RE: San Marcos WWTP - Miscellaneous Capital Improvements Project (MCIP)
Resolution 2024-103R / Contingency Reallocation No 008 / Removal and Replacement of
Structural Steel Elements at Clarifier No 401 & Installation of New Hydraulic Drive

Project:	San Marcos Capital Improvements Project		CR Number:	008
To:	Paul Kite	From:	Juan Carlos Bassi	
City of San Marcos Customer Number:	Resolution 2024-103R	CH2M HILL (Jacobs) Project Number:	DBCSCMIP

CONTINGENCY REALLOCATION

- (a) Archer Western's Request for Information No C1-RFI-004 – Status of Structural Steel Support Elements at Clarifier 401 - October 8, 2025

DESCRIPTION	SC-401	DATE	9-14-68
GENERAL ASSEMBLY		BY	
(3) 88'-0" DIAMETER		CHECKED	
SPIRAL BLADE CLARIFIERS		DATE	9-14-68
CITY OF SAN MARCOS, TEXAS		DESIGNED BY

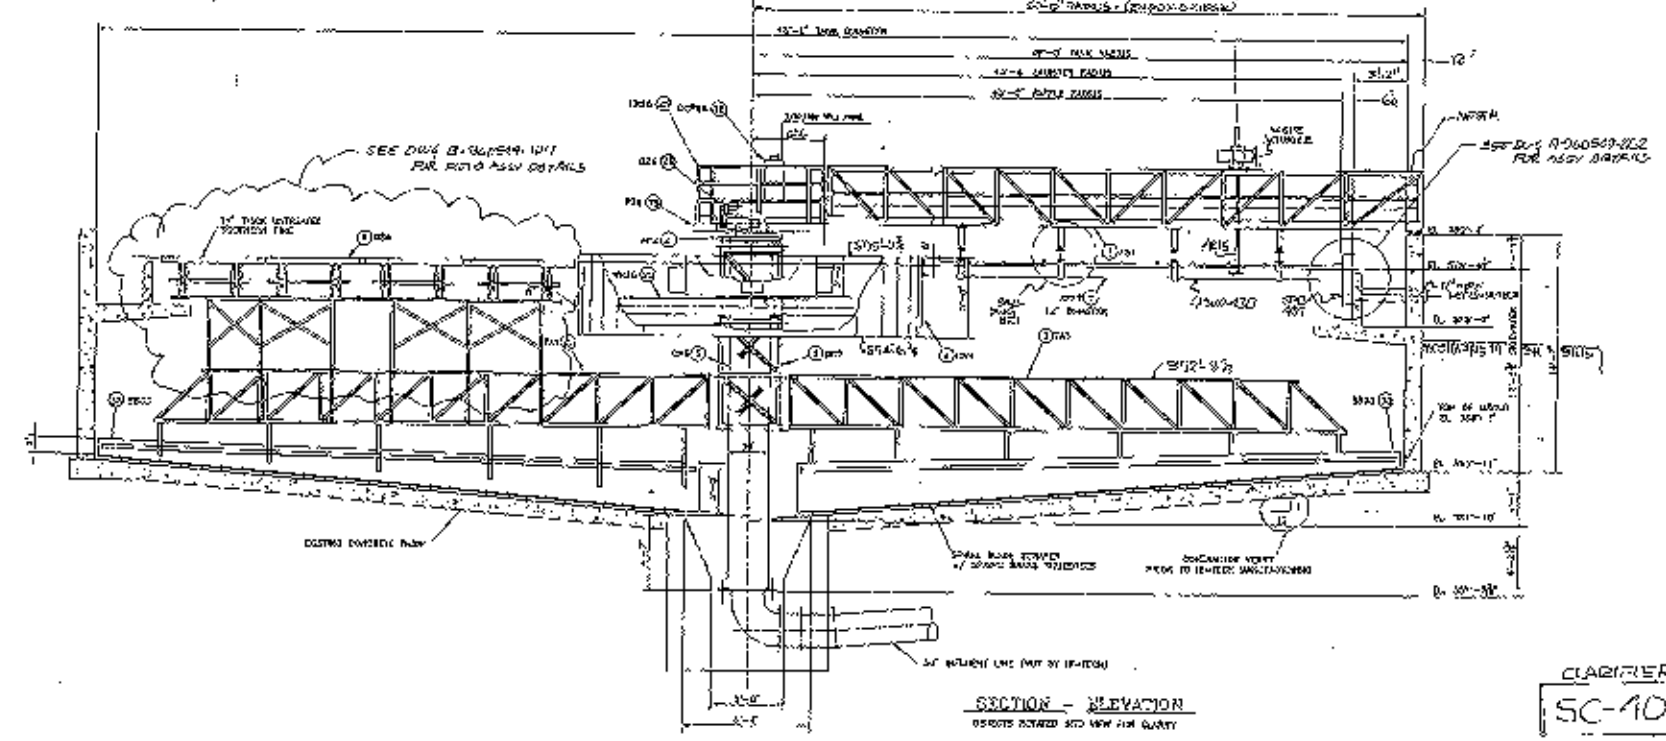
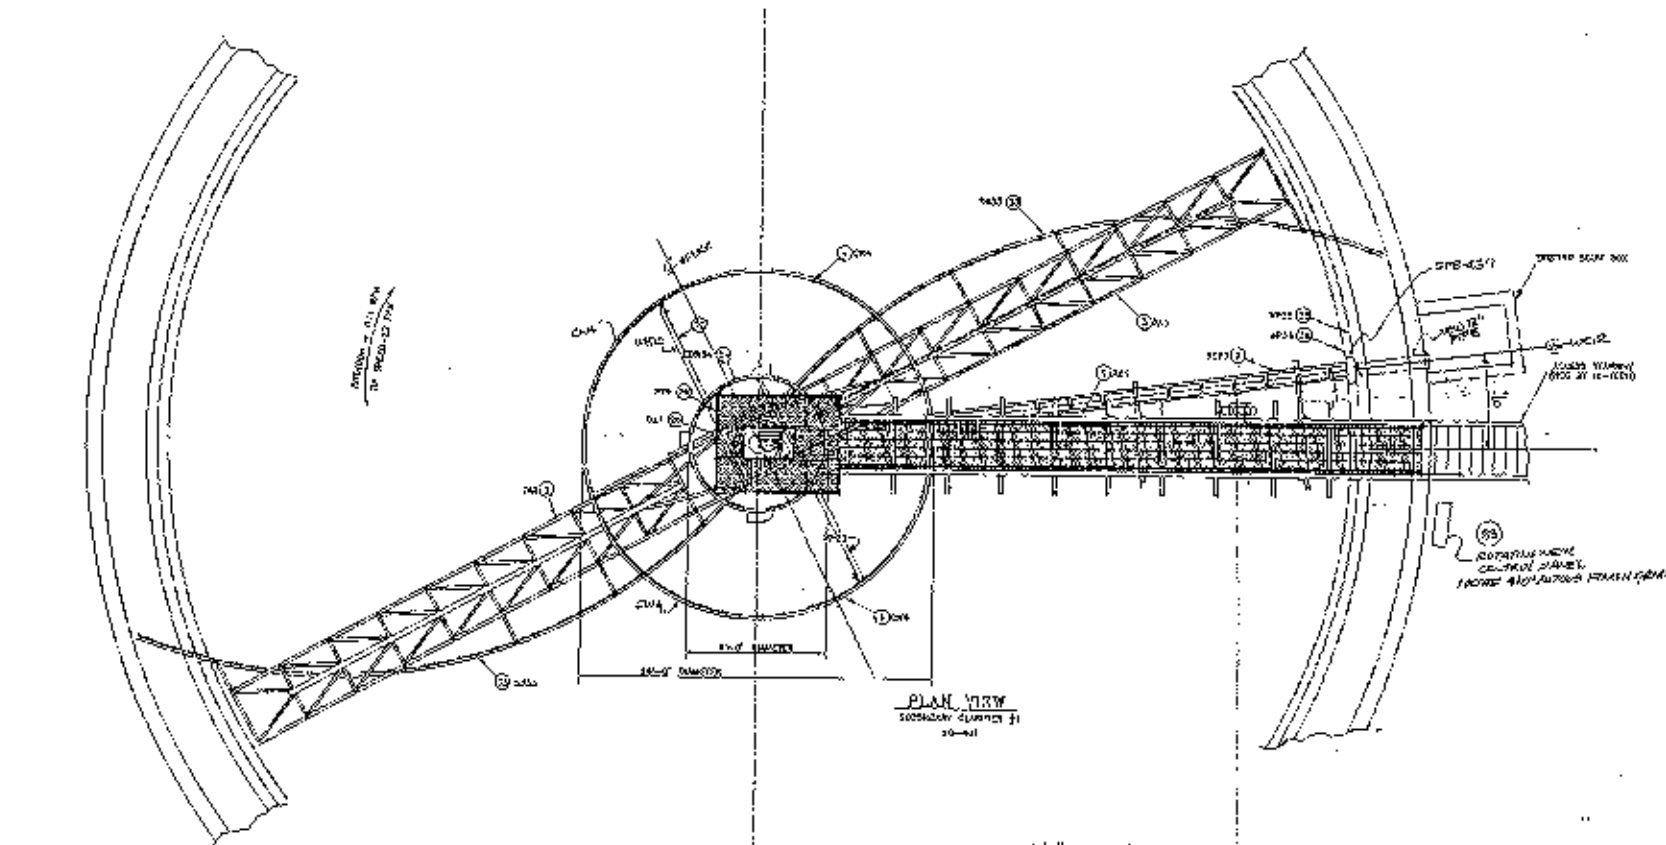
Now that secondary clarifier SC-401 is drained, Archer Western construction project team was able to complete pre work inspection before replacement drive arrives. When completing pre work inspection of secondary clarifier SC-401, Archer Western discovered the following existing conditions: There is significant rust and corrosion throughout the entire clarifier mechanical structure - in the upper and lower drive cage where Archer Western will be disassembling existing drive unit to install replacement drive unit. Disassembly of existing unit may damage upper and lower drive cage due to existing rust and corrosion, making reassembly not possible.

Please provide direction on how to proceed.

Removal and Replacement of Structural Steel Elements at Clarifier 401 to ensure operation reliability of the New Hydraulic Drive and Clarifier 401 respectively.
